# Final Determination on the Appropriateness of the Model Year 2022-2025 Light-Duty Vehicle Greenhouse Gas Emissions Standards under the Midterm Evaluation

## Response to Comments

U.S. Environmental Protection Agency  
Assessment and Standards Division

**Figure 2-7 EPA TDS24 1.17L I3 Combined Cycle Fuel Consumption Distribution vs. Engine Torque**

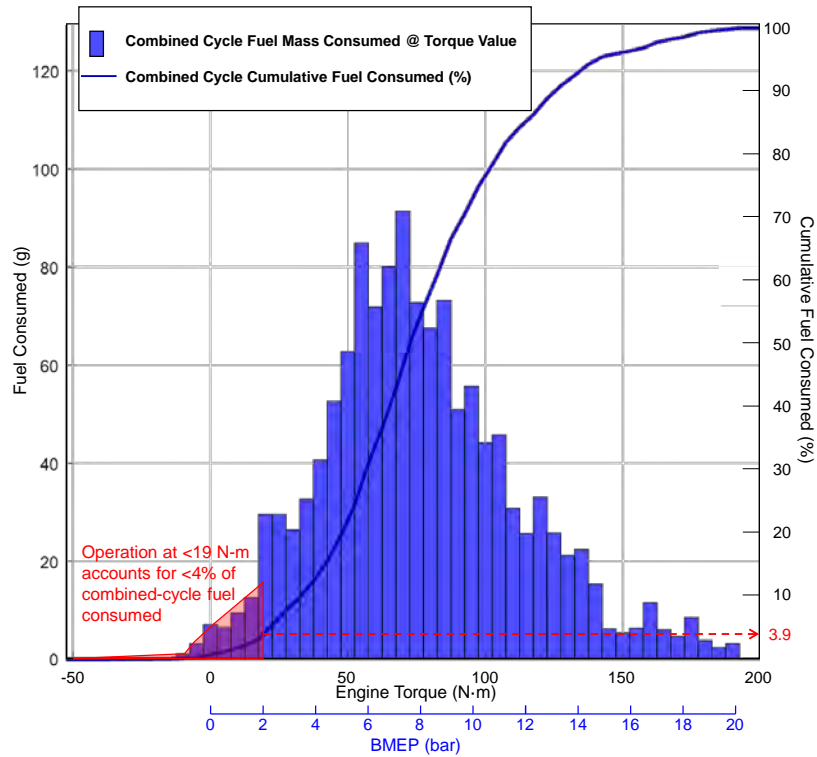
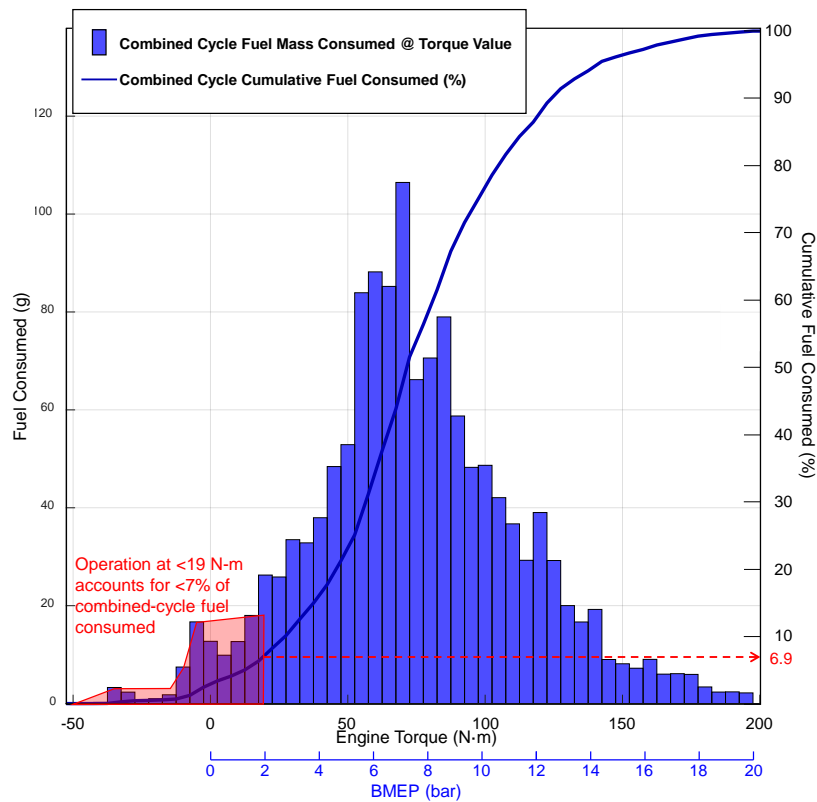
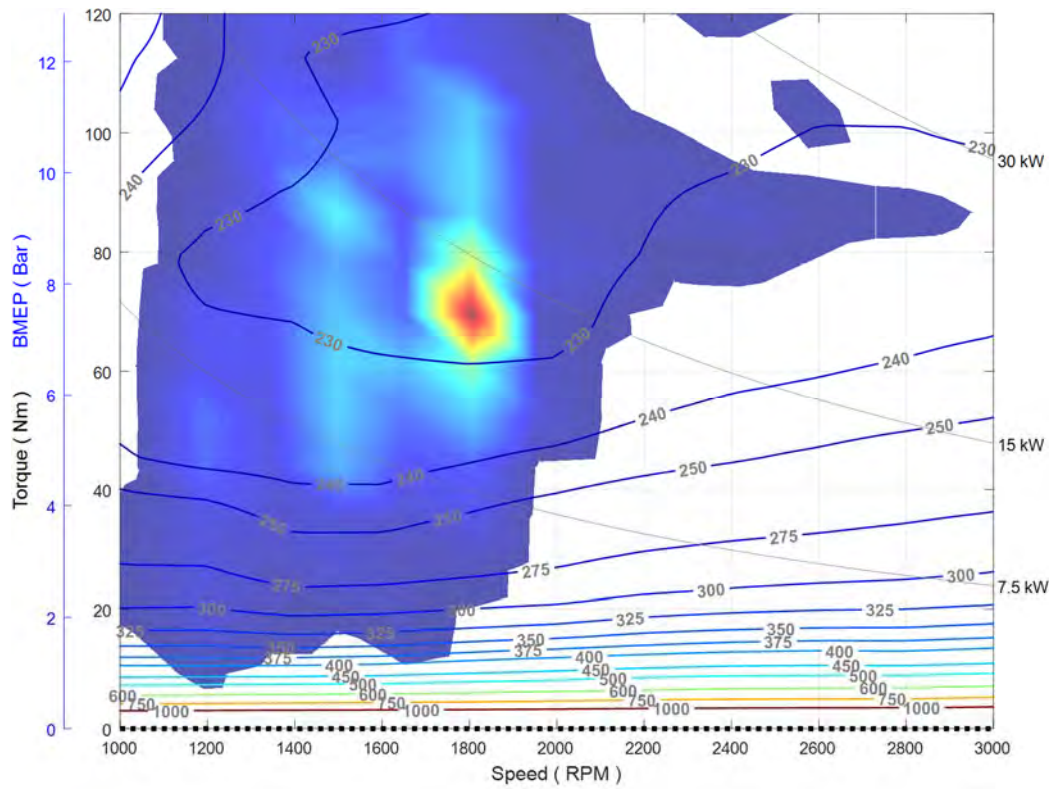
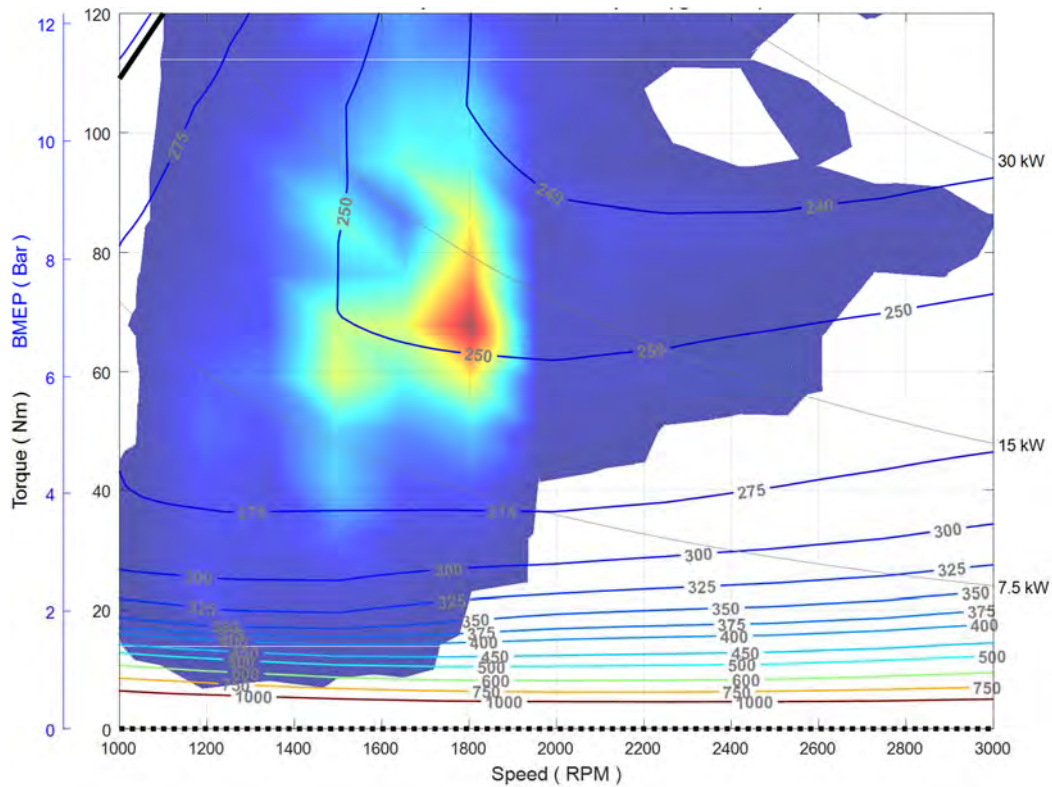
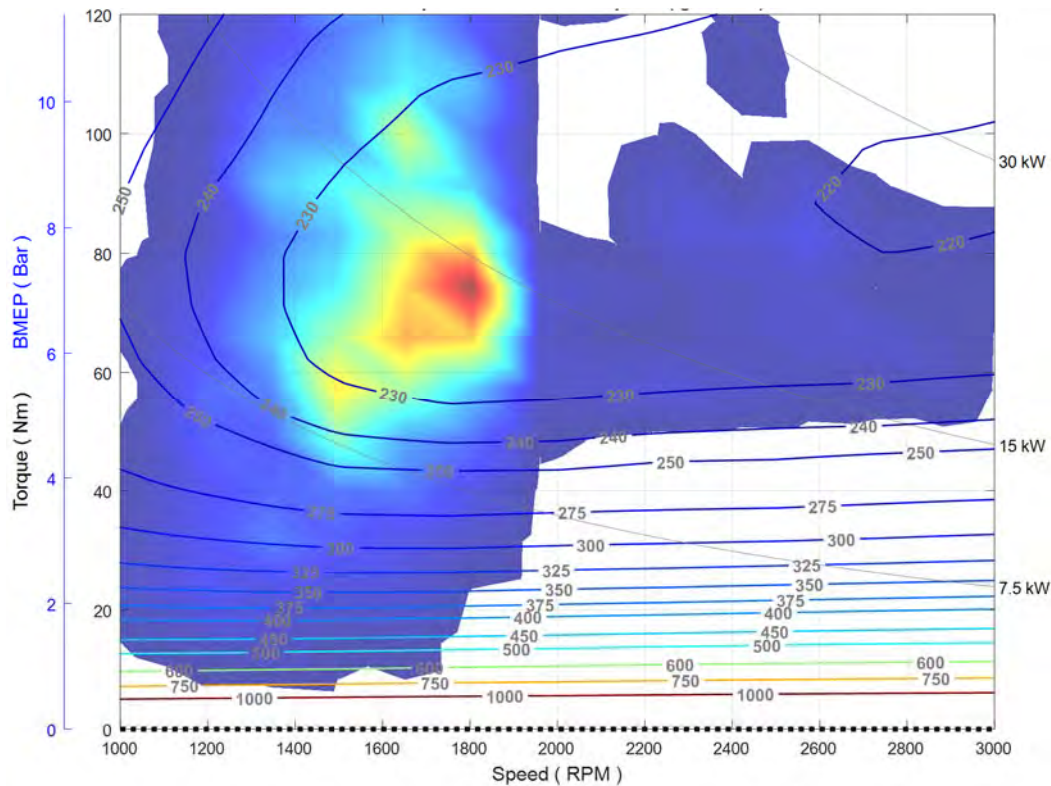
An initial analysis looked at fuel usage for a region of operation identified by the Alliance in its comments as important for compliance over the drive cycle. This region of operation within the Alliance's analysis showed 10-20% fuel differences and represented operation of TDS24 at below 2-bar BMEP or approximately 19 N-m of torque (see the Alliance comments on Proposed Determination, Figure 3). Figure 2-7 and Figure 2-8 show the contribution of mass of fuel consumed at different torque points (i.e., torque at all speeds) encountered over the combined FTP and HwFET cycles as well as cumulative fuel usage over the combined cycles for 1.17L TDS24 and a Ford 2.7L Ecoboost scaled for equivalent performance (1.24L 3-cylinder). Operation over the regulatory cycles at less than 19 N-m of torque accounted for less than 4% of fuel used by TSD24 and less than 7% of fuel used by the Ford Ecoboost 2.7, and thus the sub-19 N-m region of operation with 10-20% fuel consumption differences would account for a difference of approximately 1% over the drive cycle.

Uncertainty in fuel flow measurements increases at very light loads due to the resulting low fuel flow rates. Relatively small differences in differences in fuel flow measured at light-load (i.e., low-flow) conditions appear large on a percentage basis even if absolute differences are small and even if such operating conditions do not represent a significant contribution to cycle-integrated fuel consumption or CO<sub>2</sub> emissions. The relative importance of different speed/load conditions on fuel consumed over the drive cycles can be visualized using “heat maps” such as those shown in Figure 2-9, Figure 2-10, and Figure 2-11 for TDS24, and the scaled Ford Ecoboost 2.7L and Honda L15B7 engine configurations, respectively. Please note that the heat maps were plotted over the same 1000-3000 rpm and sub-120 N-m torque operational range shown within Figure 2 and Figure 3 of the Alliance comments to the Proposed Determination and do not reflect the full range of engine operation. The “heat maps” indicate that fuel consumption differences at higher load conditions than those identified by the Alliance (e.g., from approximately 40 N-m to approximately 110 N-m torque) would be significantly more important with respect to drive cycle fuel consumption and CO<sub>2</sub> emissions than operation at less than 19 N-m of torque for the specific examples shown here and within the Alliance comments to the Proposed Determination.

**Figure 2-12 Percentage Differences in Fuel Consumption Between The 1.17L TDS24 and the MY2015 Ford Ecoboost 2.7L Engines (left) and between the MY2017 Honda L15B7 and the MY2015 Ford Ecoboost 2.7L Engines.**

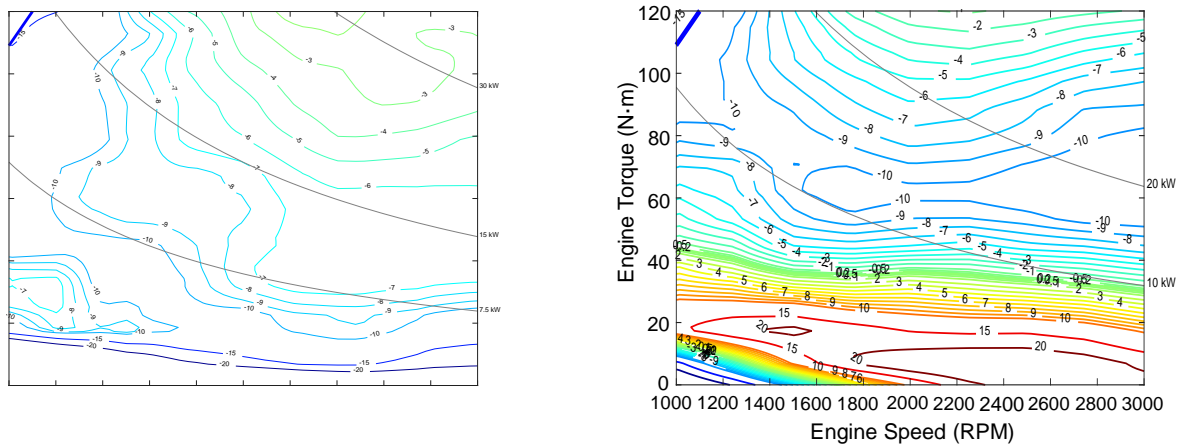
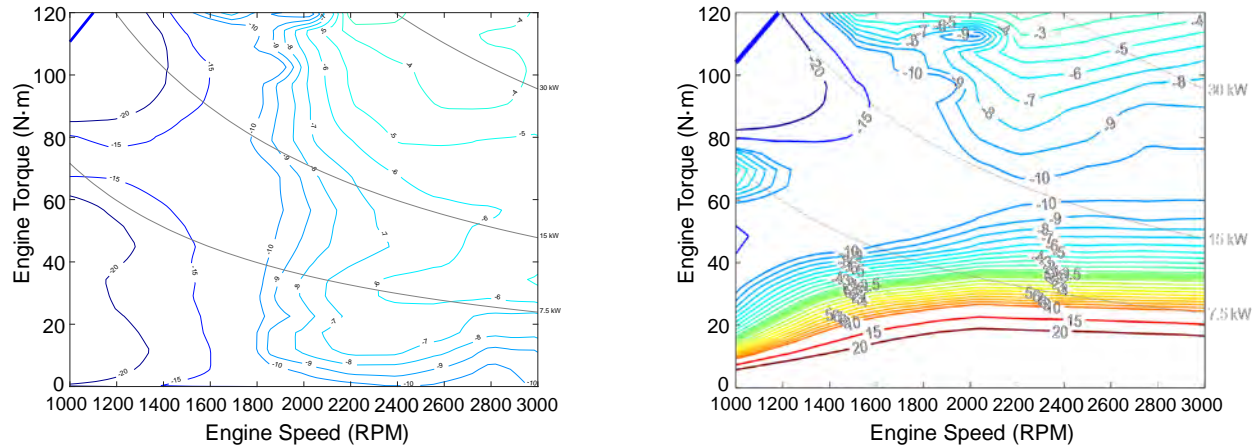
Figure 2-12 and Figure 2-13 are EPA’s recreation of Figure 2 and Figure 3, respectively, from the Alliance comments to the Proposed Determination showing fuel consumption differences between 1000 – 3000 rpm and below 120 N-m of torque. Figure 2-12 shows a comparisons of

When properly scaling the engines for equivalent torque, EPA's analysis found somewhat larger differences at light loads between TDS24 and the scaled Ford Ecoboost 2.7L and significantly larger differences relative to the ANL 24-bar configurations. Comparing the scaled Honda L15B7 engine to the scaled Ford Ecoboost 2.7L and the ANL 24-bar configuration showed remarkably similar differences to those found with the comparison to TDS24 despite the Honda engine's lack of some of the technologies used for TDS24 (e.g., cEGR, VVL and VNT).
